Memorandum

To: Town of Washington Planning Board
From: AKRF, Inc.
Date: January 13, 2025
Re: **Clear Subdivision (515 Woodstock Road) – NRI Map #8**
cc: Timothy Clear and Johna Lee Clear (Applicant / Property owner)
 Douglas E Larson – Larson Architecture Works PLLC (Applicant’s Architect)
 LRC Group (Applicant’s Planner / Engineer)
 Jennifer Van Tuyl – Cuddy + Feder LLP (Applicant’s Attorney)
 Joseph P. Eriole (Town Attorney)
 Jonathan Ialongo (Town Building Inspector)

NRI Map 8 - Drinking Water Resources (subject property in red)

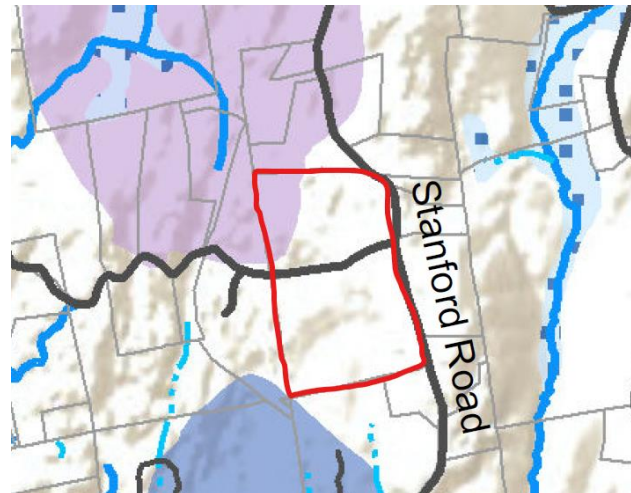
Map 8 shows the northwestern extent of the Clear property in the tertiary recharge zone. The tertiary recharge map layer relates to proposed Parcel 1 (the northwest parcel) of the Applicant’s proposed subdivision.

As shown on Map 8, the secondary and primary recharge zones are a considerable distance away from the parcel (1 to 2 miles). Also, as was observed on the site walk, it was evident that the land within the Applicant's proposed building envelope for Parcel 1 slopes/drains in a south/southeasterly direction, not to the north/northwest. It should also be noted that there are homes and developed areas within that tertiary zone shown on the map throughout the Town. Residential septic systems also exist, and can be permitted/constructed within, a primary recharge area.

The Planning Board may request that the Applicant generate, for the record, an exhibit that overlays the tertiary aquifer recharge zone on to the proposed building envelope for Parcel 1, along with a response from the Applicant's engineer related to this issue.
